# Flood Risk Assessment & Drainage Strategy

## 7270 – Proposed Commercial Development

Report: 7270-HJCE-ZZ-XX-RP-3000.v3

## 10. Kirklees Council (LLFA) Consultation Comments

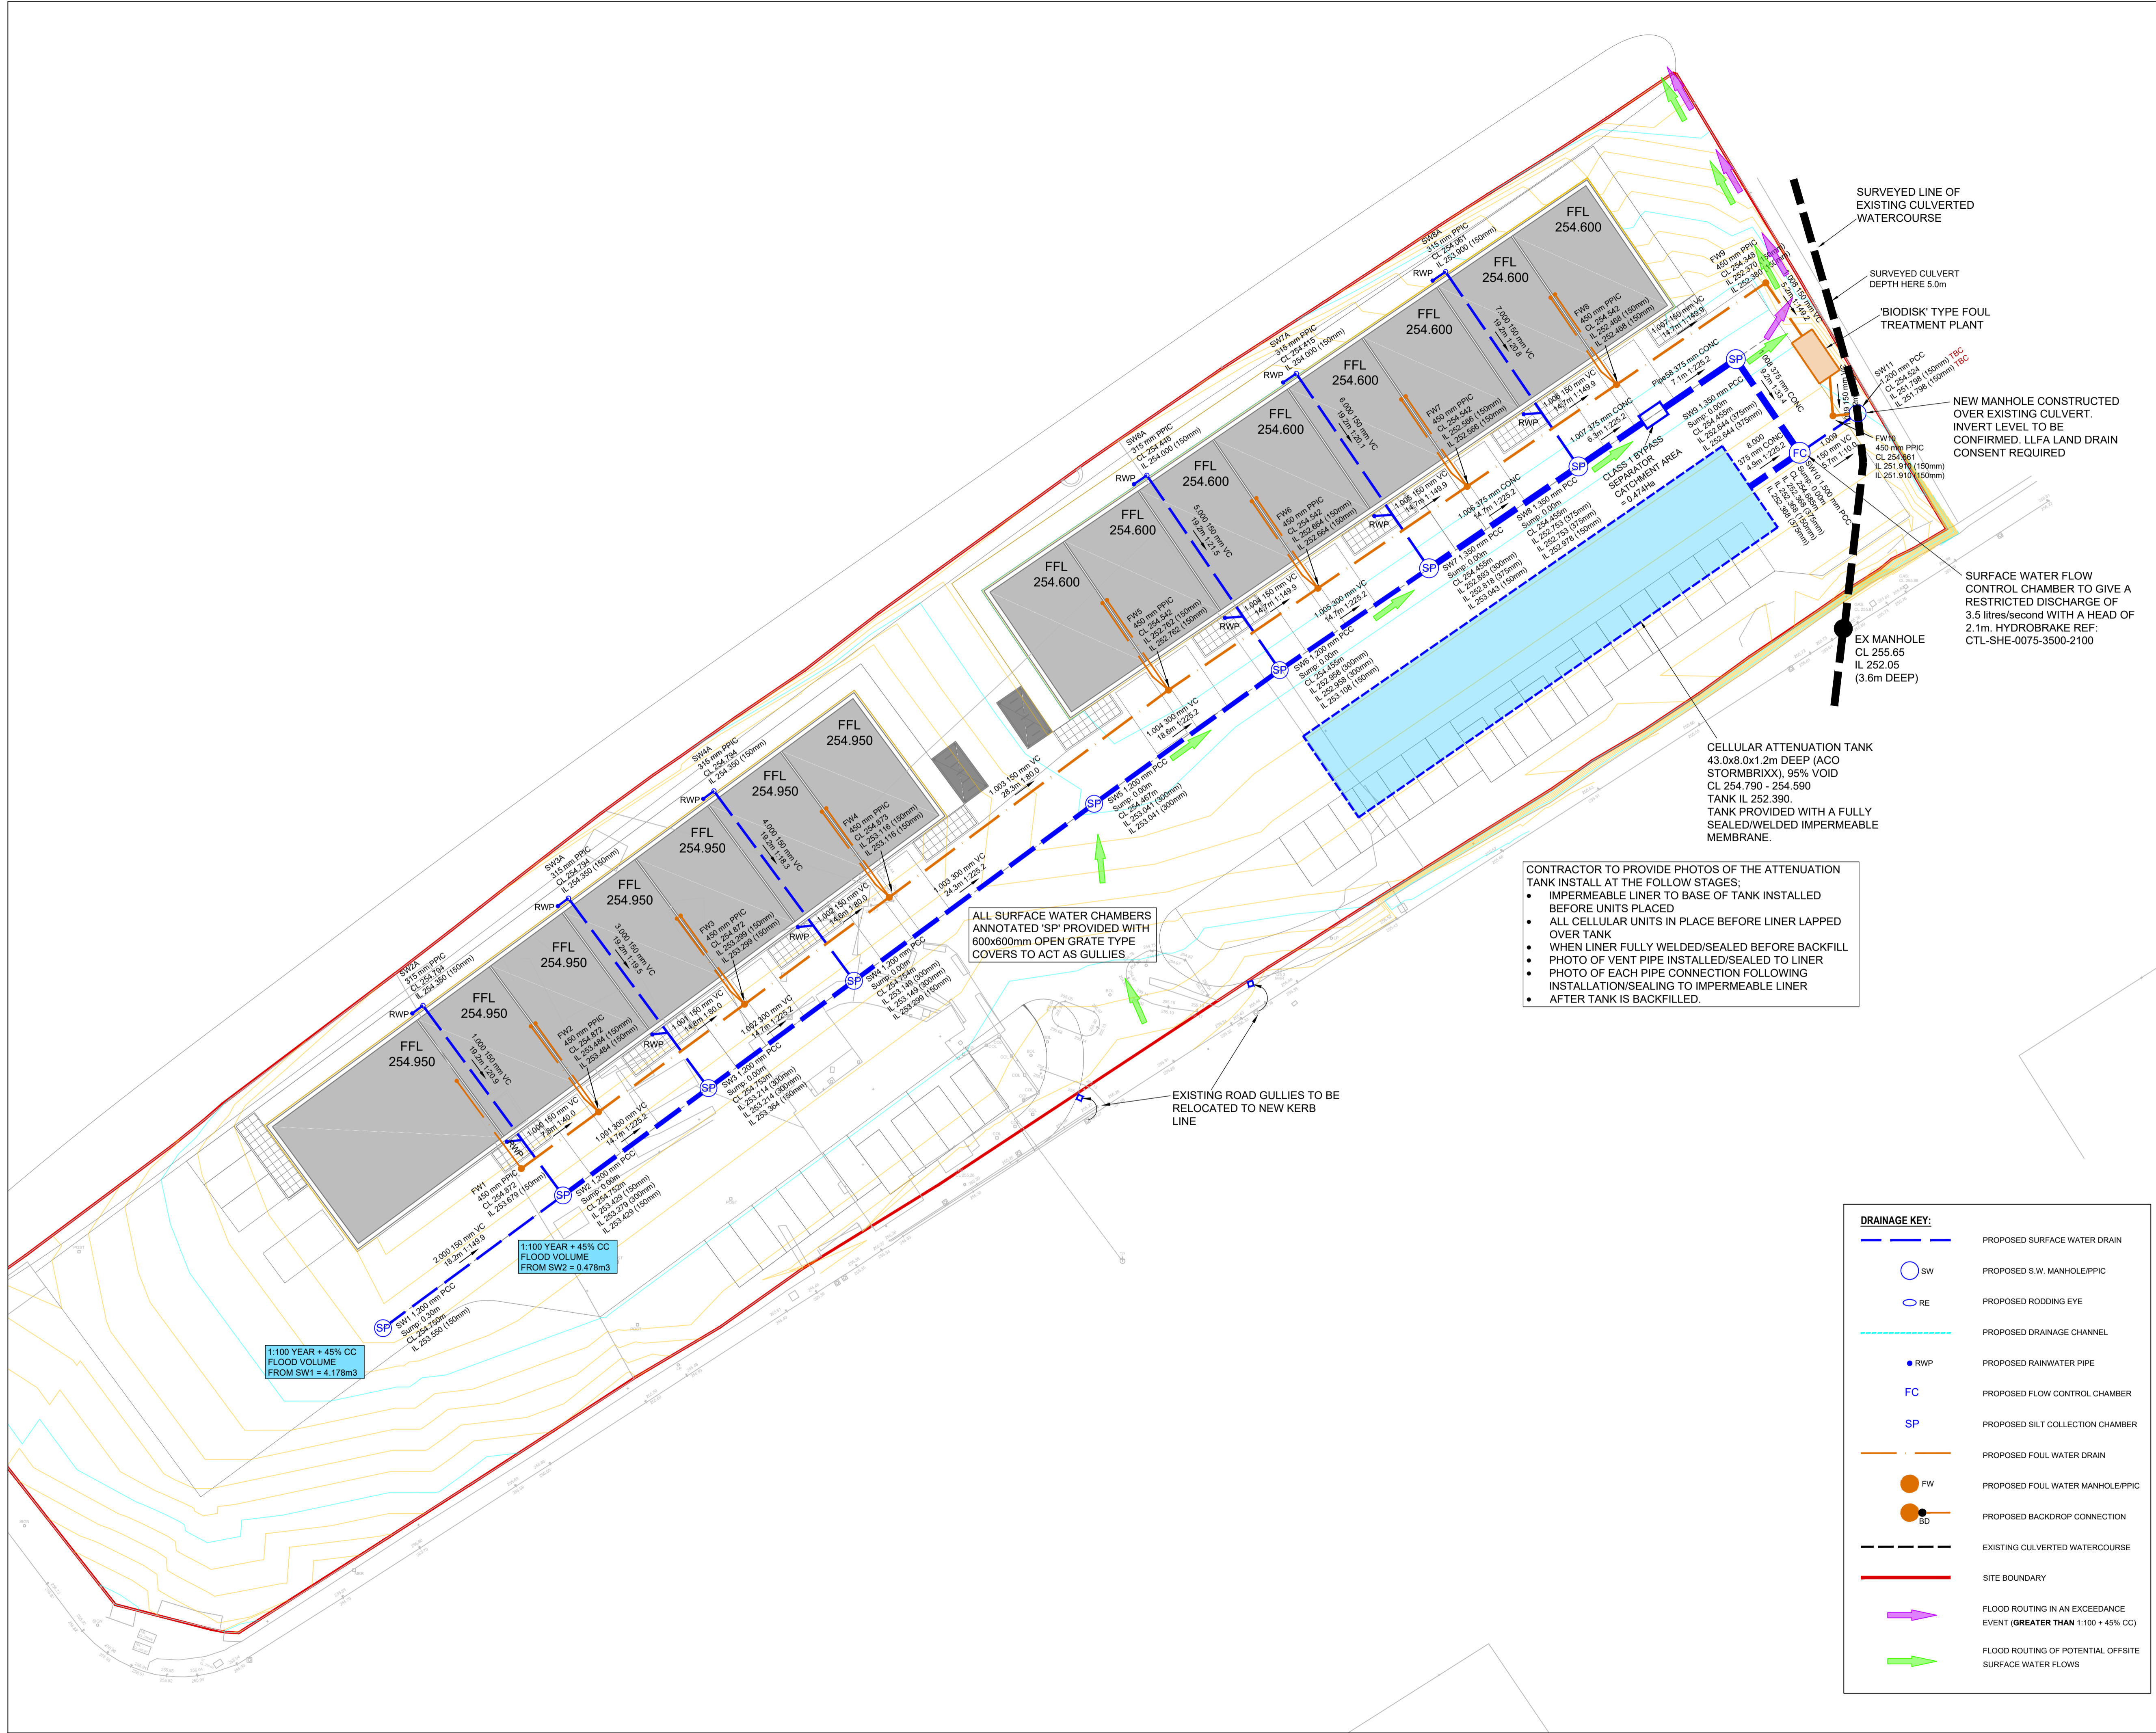
- It is understood from testing at the nearby Peat Ponds Farm site that soakaways are an unsuitable method of surface water disposal. BGS data suggests severe constraints on this site for infiltration techniques. A 3.5l/s restriction to watercourse should apply given the existing buildings drain to ground. *Surface water has been restricted to 3.5 litres/second as identified on HJCE drainage drawing no. 7270-HJCE-XX-XX-DR-C-3000 in Appendix I.*

- The layout must be shown to have 'made space for water' including conservative estimates for SUDS systems volumes for attenuation and treatment. This will be more demanding given the restriction imposed on the outflow and the culvert appears to clash with the area chosen to attenuate surface water. *Surface water attenuation is to be provided in a below ground cellular tank as identified on HJCE drainage drawing no. 7270-HJCE-XX-XX-DR-C-3000 in Appendix I. Surface water drainage calculations are provided in Appendix J.*

- Accommodation of the existing watercourse crossing site should be demonstrated, independent of the attenuation feature and not be built over, having a suitable standoff distance. *Refer to HJCE drainage drawing no. 7270-HJCE-XX-XX-DR-C-3000 in Appendix I for the location of the existing culvert and proposed drainage.*

- Suitable flood routing needs to be picked up in the flood risk assessment showing current flows

- An analysis of the depth of potential surface water flooding in the northeast corner is required. Layout could be affected. An assessment of surface water flooding from the proposed drainage system is included on [HJCE drainage drawing no. 7270-HJCE-XX-XX-DR-C-3000 in Appendix I](#), there is a flooded volume of circa 3m<sup>3</sup> which will be accommodated on the yard surface. The Environment Agency flood maps indicate a localised area of flooding in the northeast corner of the site, this is as a consequence of a local low area of ground topography as identified on the topographic survey in Appendix N. As the site is developed with a formal drainage system this will significantly reduce any surface water flooding in this area. The proposed building and yard levels are circa 1.5m above the area of potential surface water flooding, therefore any residual ponding in this area will not impact the development.

- The site will need to accommodate a treatment works with an appropriate standoff distance and access provision. This also needs to be shown in any layout indicative or otherwise. [The foul treatment plant is indicated on HJCE drainage drawing no. 7270-HJCE-XX-XX-DR-C-3000 in Appendix I.](#)

- A petrol interceptor or SUDS alternative is advised where 50+ parking spaces are made available or car parking provision amounts to 800 square metres or more. [The petrol interceptor is indicated on HJCE drainage drawing no. 7270-HJCE-XX-XX-DR-C-3000 in Appendix I.](#)

and future flows and whether the design may open a route from Lindley Moor Road that has to be managed. The FRA is incomplete in this respect. [Flood routing is indicated on HJCE drainage drawing no. 7270-HJCE-XX-XX-DR-C-3000 in Appendix I.](#)
